Date: April 6, 1994

Re: Site Evaluation Denial for On-Site Sewage Disposal
T5N, R10W, Section 29BD, Tax Lot 100, Clatsop County,
25.37 Acres.

SITE EVALUATION FIELD WORKSHEET

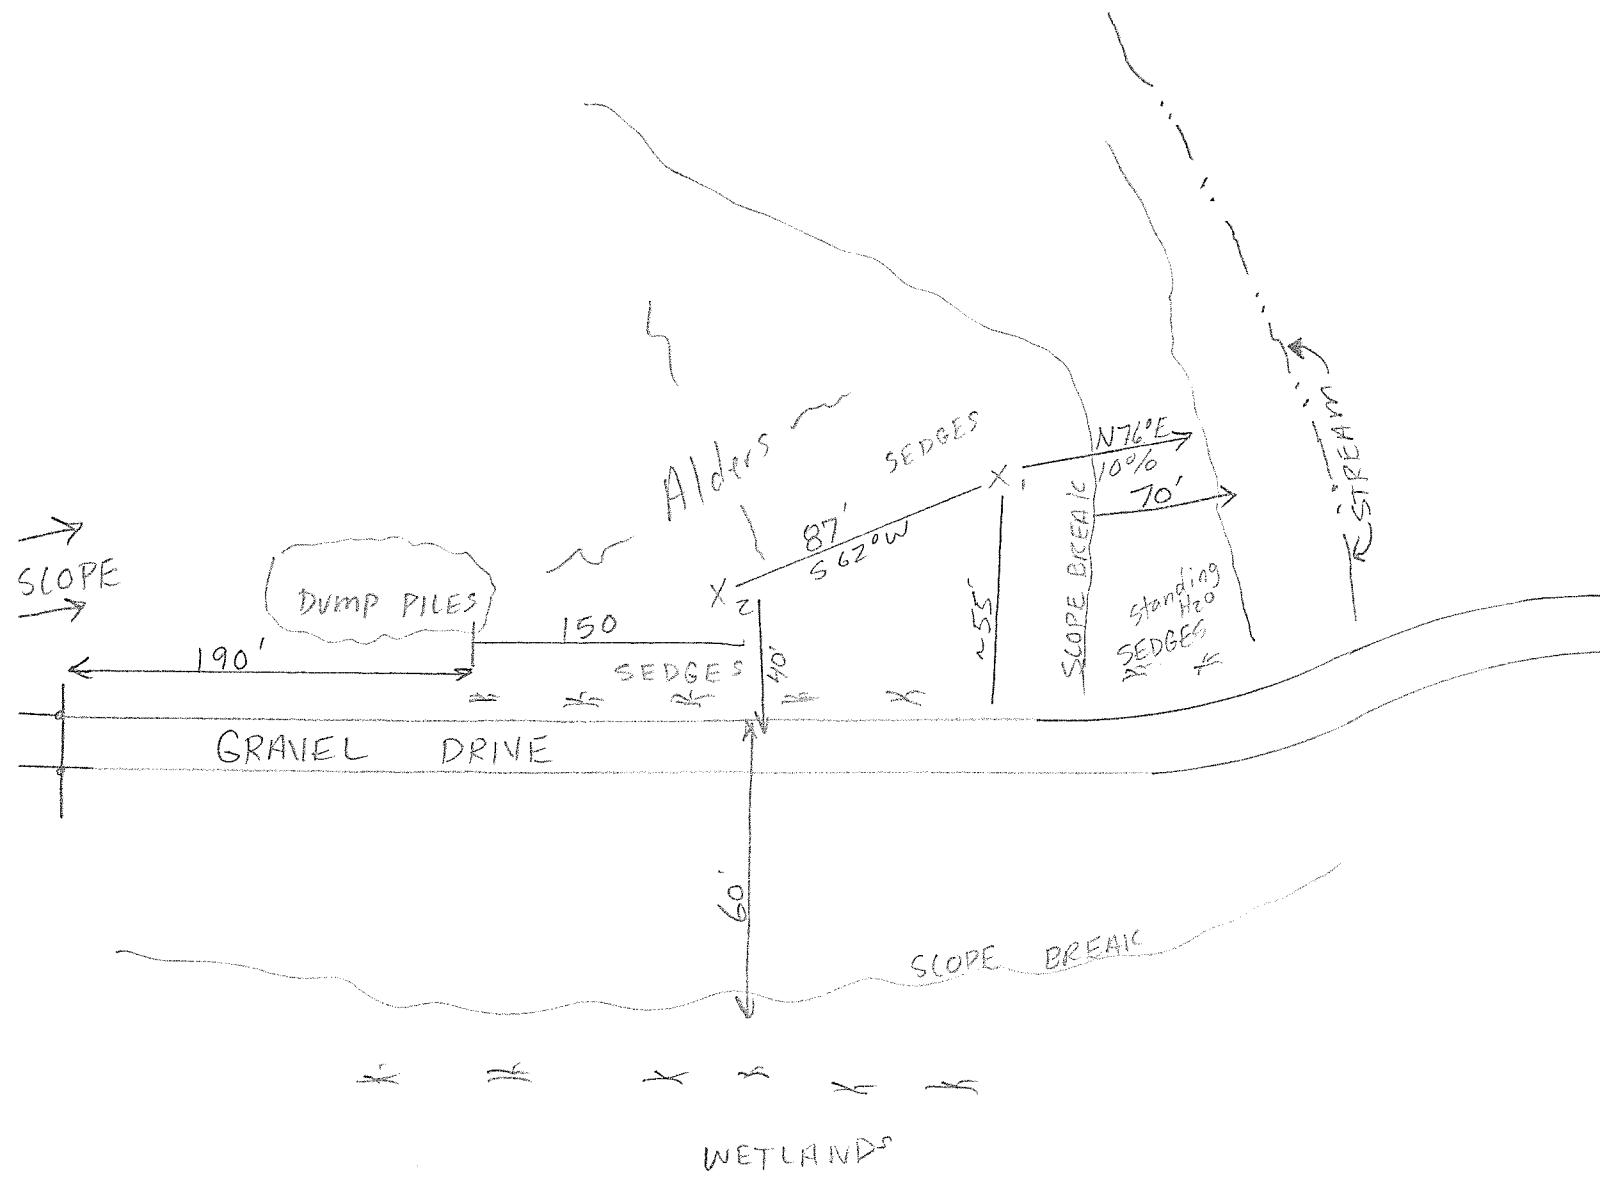
Pit 1	0-4"	Sil	10YR 3/2 dk. grayish brown loose	
	4"-15"	Sil	Siltstone fragments soils filled modified	22" ESD
	15"-45"	C	10YR 5/1 w/ 7.5 YR 3/4 mottles, massive	31" fill line
	45"		H ₂ O

Pit 2	0-2"	N/A	0" horizon 10YR 2/1	
	2"-10"	Sil	10YR 5/1 mixed gray clay	
	10"-15"	C	Shale / massive gray clay, very dense. 10YR 5/1 gray	
	15"-37"	C	Same ESD	
	37"	N/A	H ₂ O

Landscape Notes Filled Site

Slope 0-10% Aspect NE Groundwater Type Temporary
